HISTORIC AND DESIGN REVIEW COMMISSION

October 19, 2022

HDRC CASE NO: 2022-506
ADDRESS: 825 E HARLAN AVE
LEGAL DESCRIPTION: NCB 7729 BLK 9 LOT E 171.7 FT OF 11 THRU 14, EXC SE 6.50FT X 10.15FT
ZONING: MF-33, H
CITY COUNCIL DIST.: 3
DISTRICT: Mission Historic District
APPLICANT: Kevin Sekula/SEKULA KEVIN
OWNER: Kevin Sekula/SEKULA KEVIN
TYPE OF WORK: Installation of doors and windows, driveway modifications
APPLICATION RECEIVED: September 19, 2022
60-DAY REVIEW: Not applicable due to City Council Emergency Orders
CASE MANAGER: Jessica Anderson
REQUEST:

P

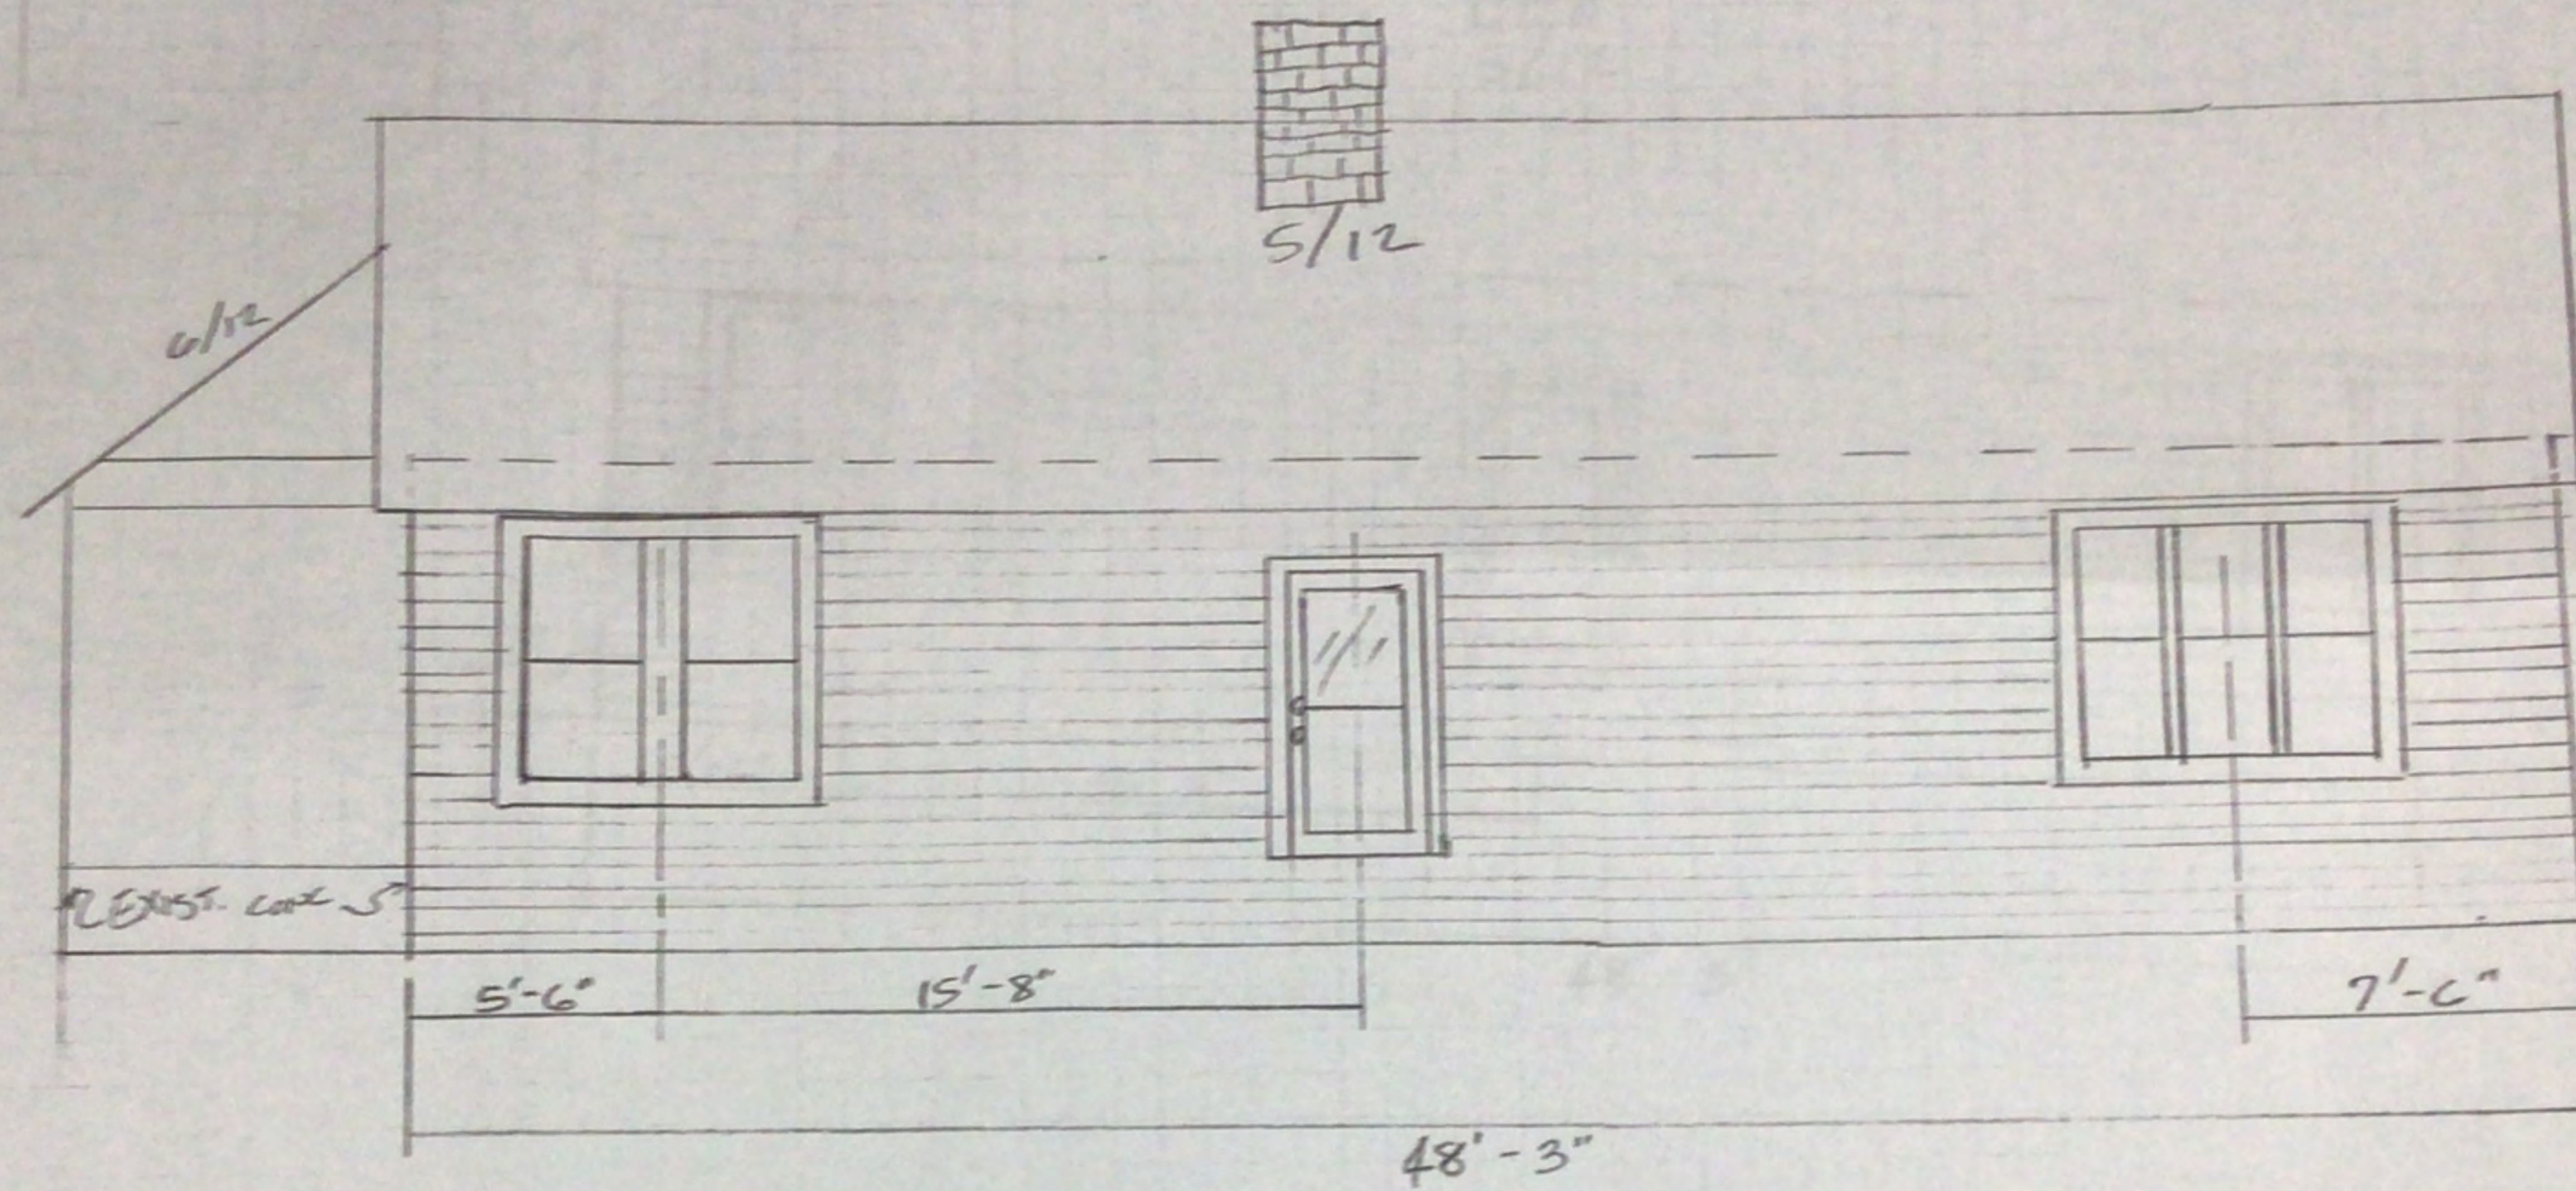
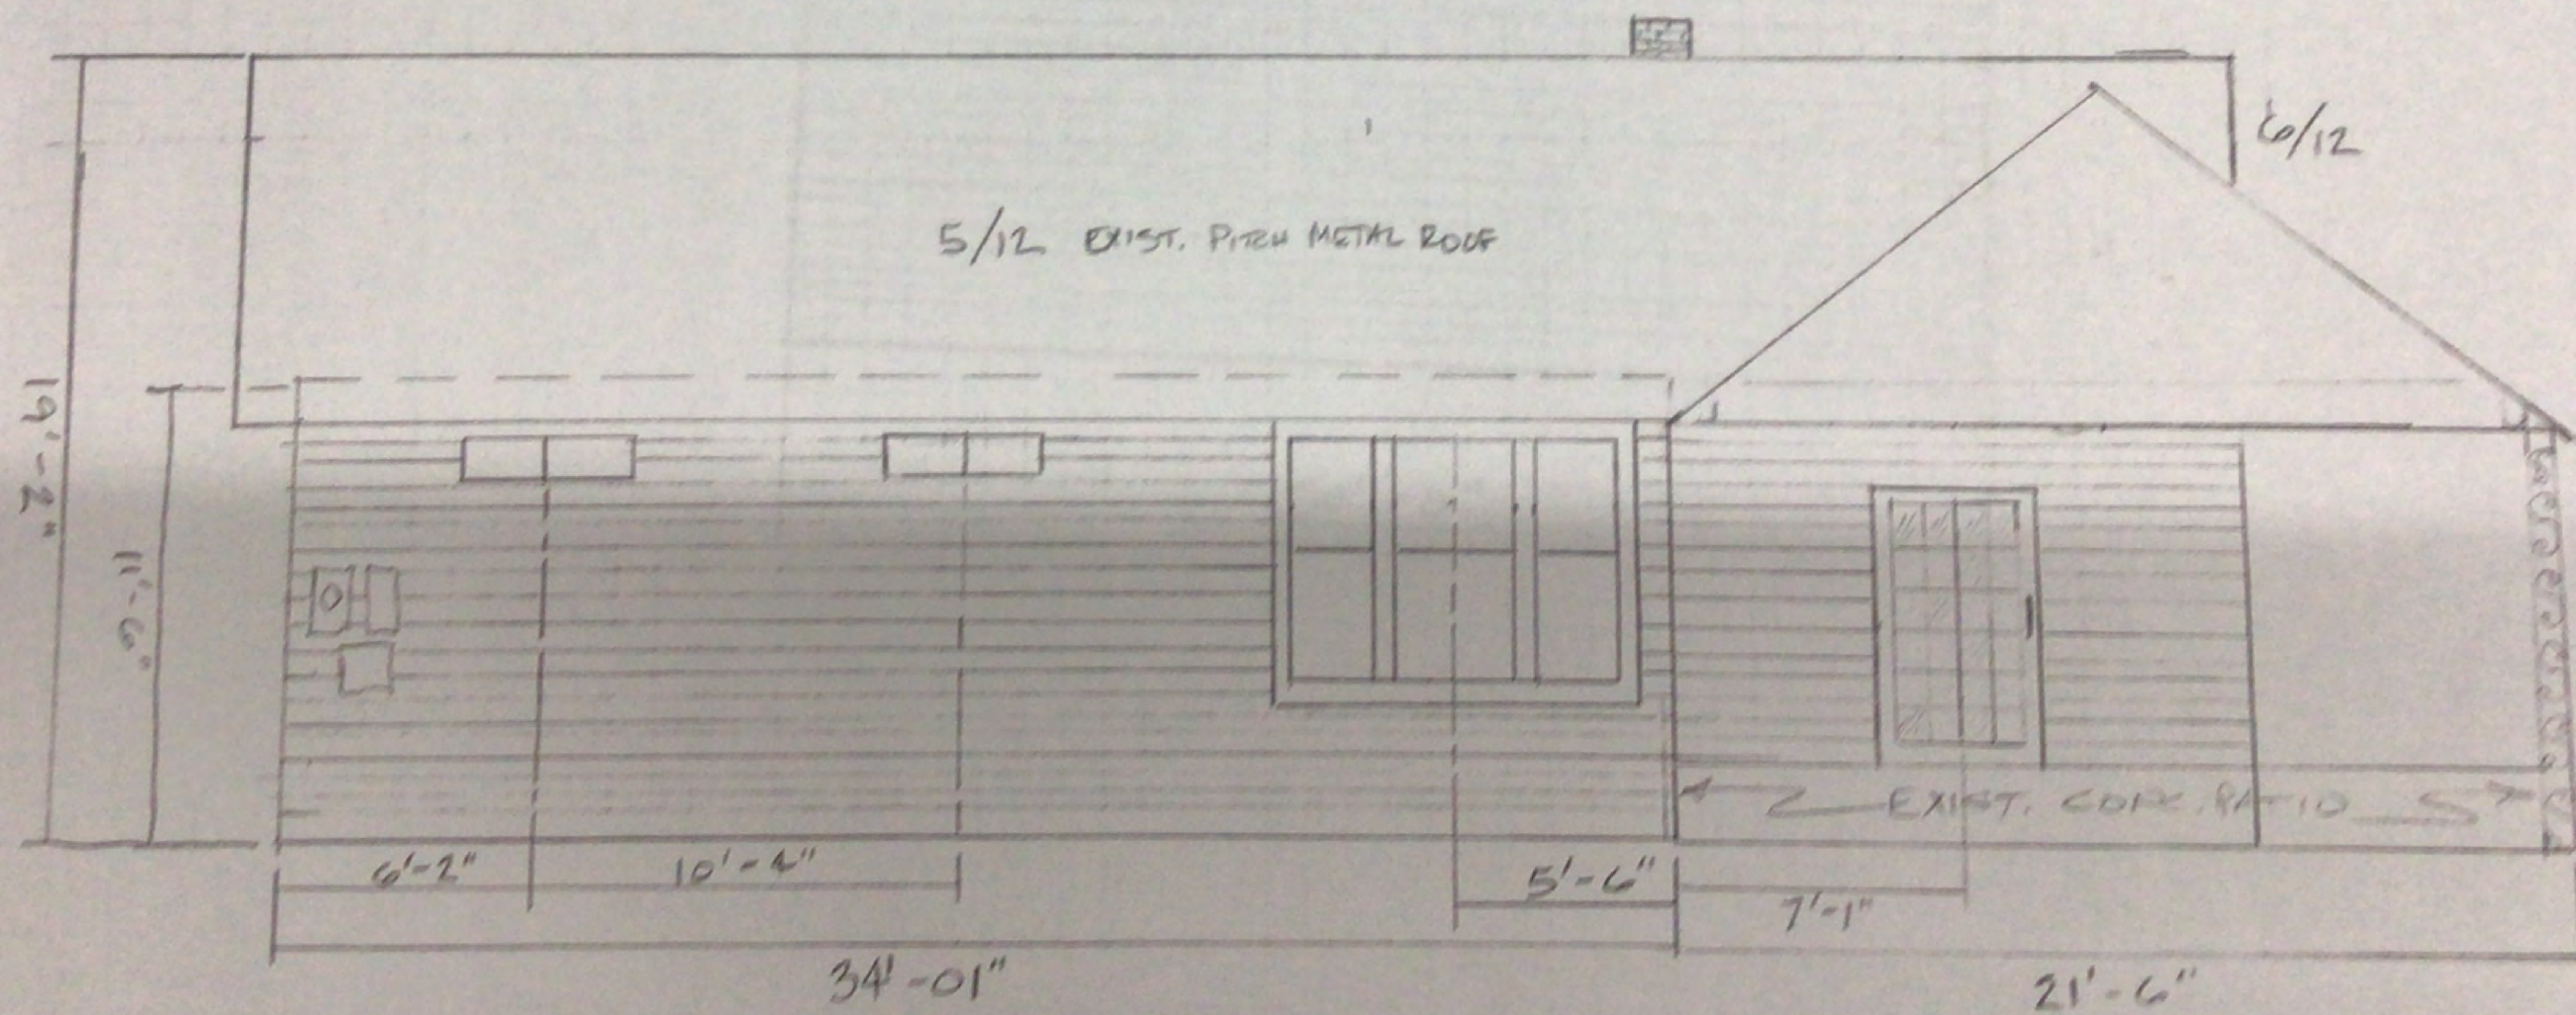
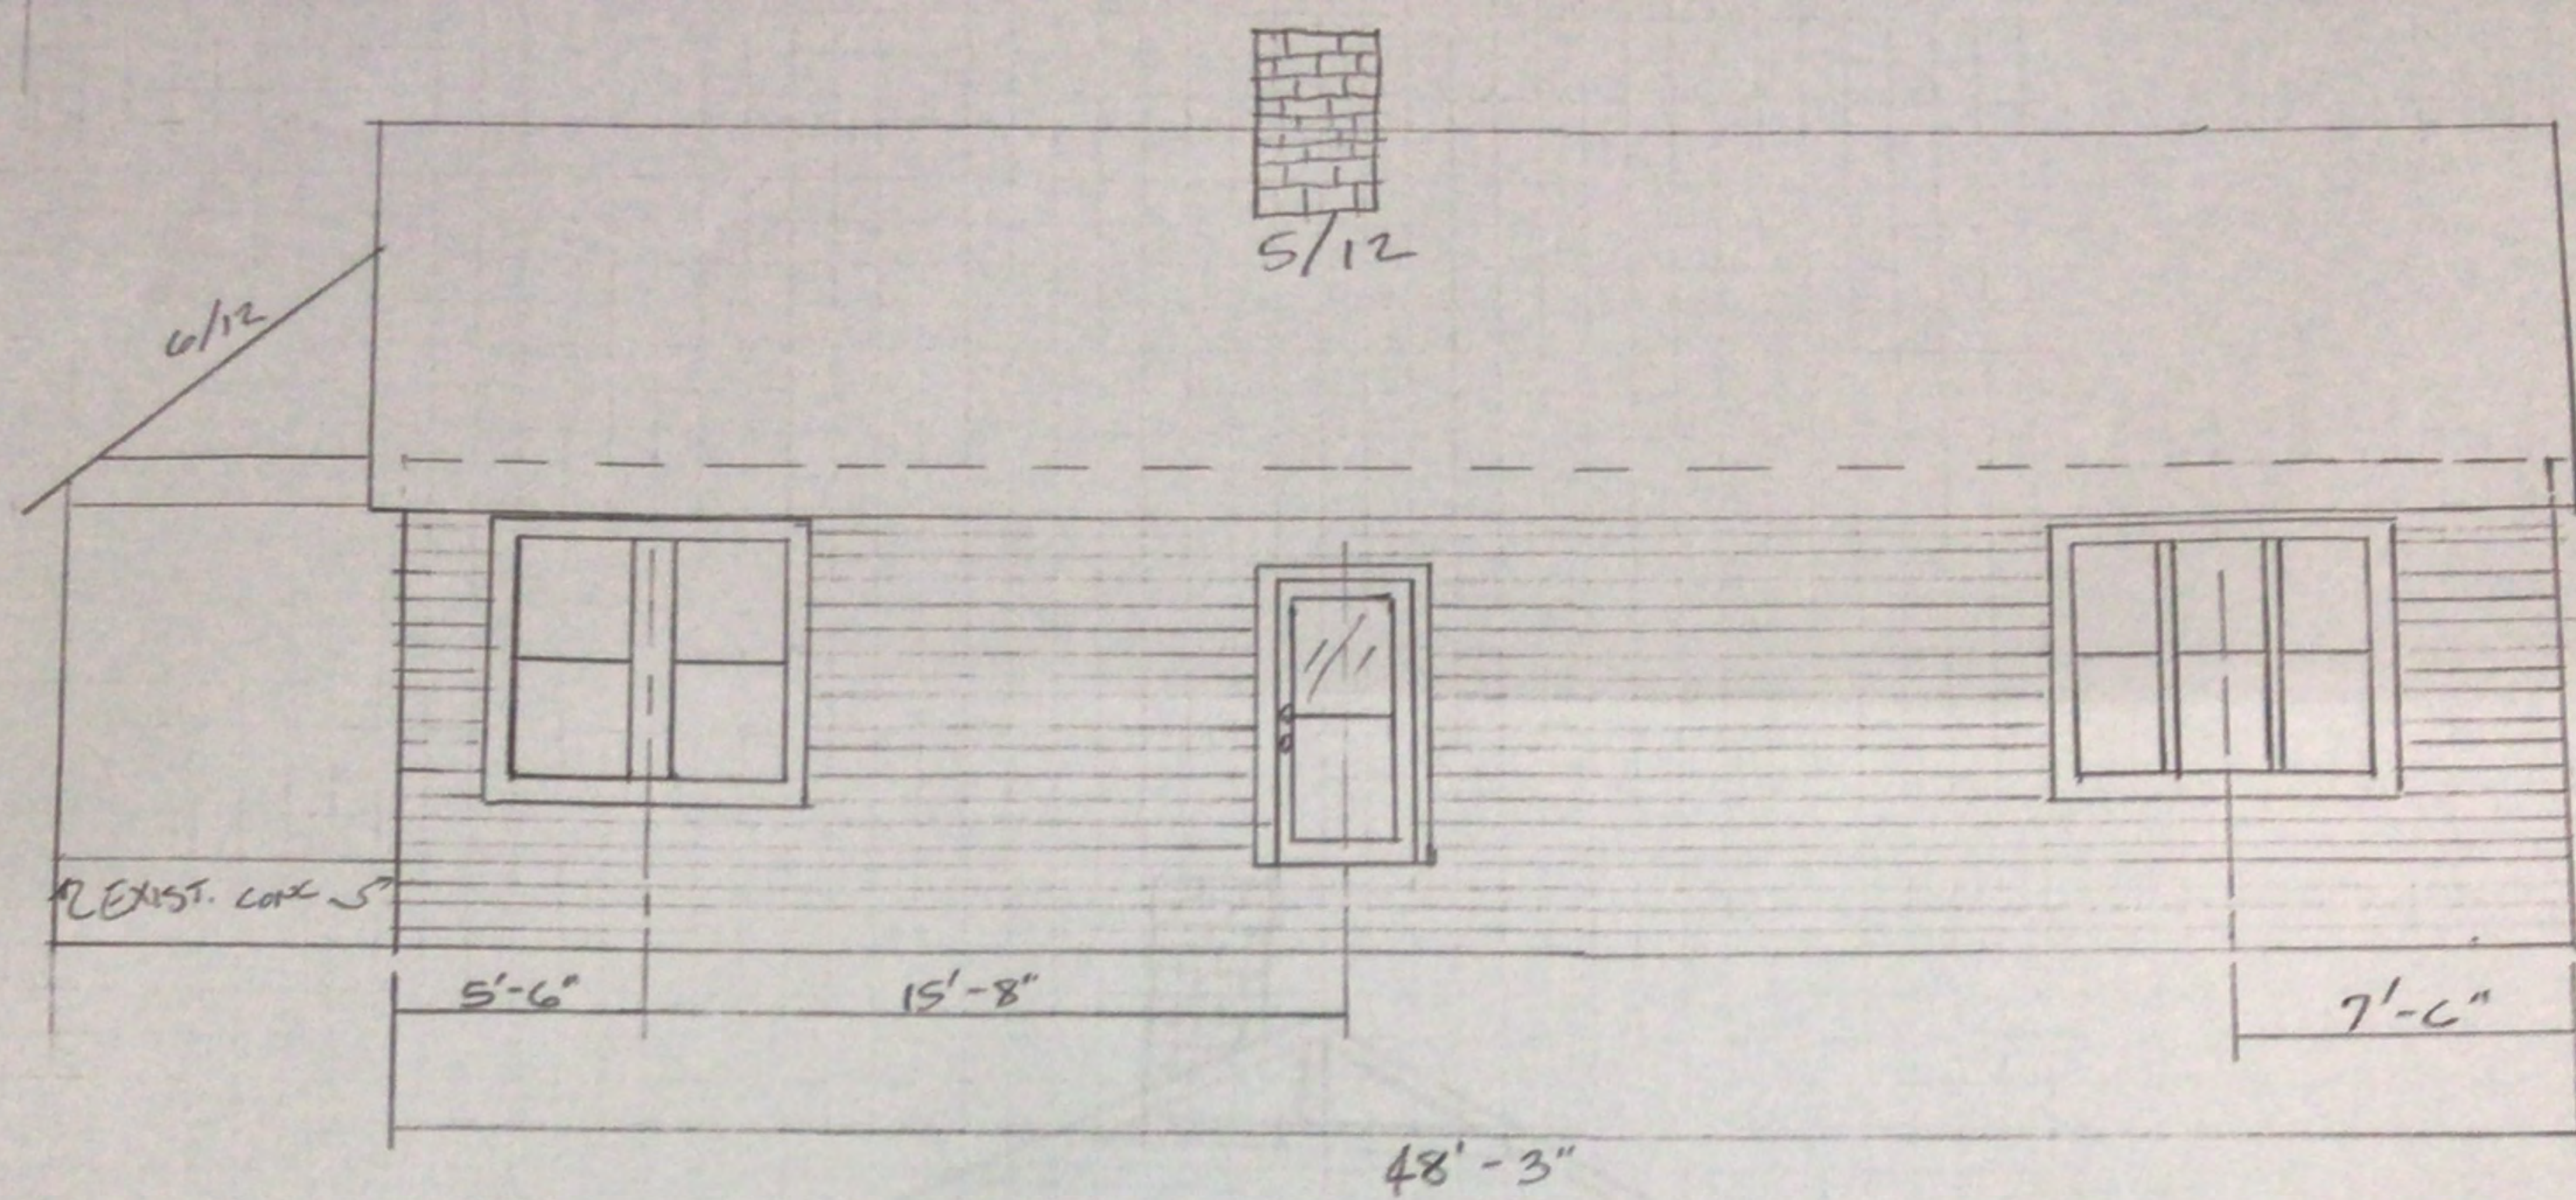
W1 - MOVE & FROM 10'-7" TO 7'-6"

D1 - DELETE

W2 - CHANGE TO EXT. DOOR 3' 6"

W3 - CHANGE & FROM 7'-1" TO 5'-6"

W5, D2 & W6 REMOVE & MATCH W4

D3 - CHANGE TO SINGLE 4' 6"

W7 - NO CHANGE

W8 - CHANGE FROM DBL TO (2) SINGLE 1" TALL X 3" WIDE

W7A - ADD (1) SINGLE 1" TALL X 3" WIDE

W9 - DELETE

Staff does not recommend approval of item 3, changing the fenestration pattern across all elevations, based on finding d.
